**COMMITTEE OF EXPERTS ON THE TRANSPORT OF
DANGEROUS GOODS AND ON THE GLOBALLY
HARMONIZED SYSTEM OF CLASSIFICATION
AND LABELLING OF CHEMICALS**

**Sub-Committee of Experts on the
Transport of Dangerous Goods**
(Twenty-second session, 2-6 December 2002,
agenda item 2)

ADDITIONAL PROVISIONS FOR THE TRANSPORT OF GASES

Report of the Working Group

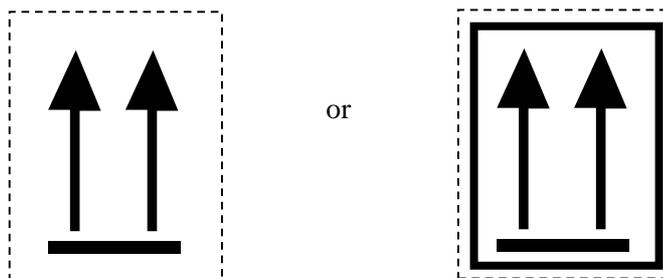
Add a new provision to Chapter 5.2 as follows:

5.2.2.1.13 The following orientation label shall be displayed on two opposite sides of cryogenic receptacles intended for the transport of refrigerated liquefied gases. They shall be rectangular, of standard format 74 x 105 mm (A7). If the size of the package so requires, the dimensions of the labels may be changed, provided that they remain clearly visible.

Two black or red arrows on white
or suitable contrasting background

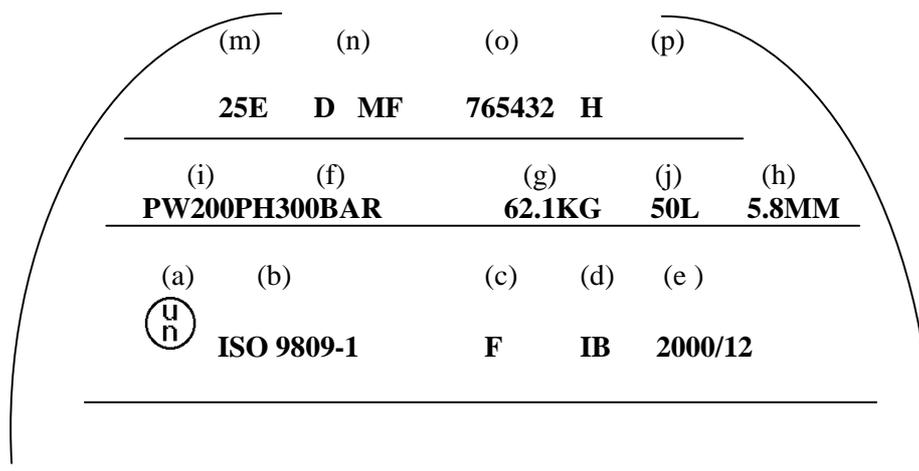
6.2.2.67.4 The above marks shall be placed in three groups ~~as shown in the example below~~:

- Manufacturing marks shall be the top grouping and shall appear consecutively in the sequence given in 6.2.2.67.3.
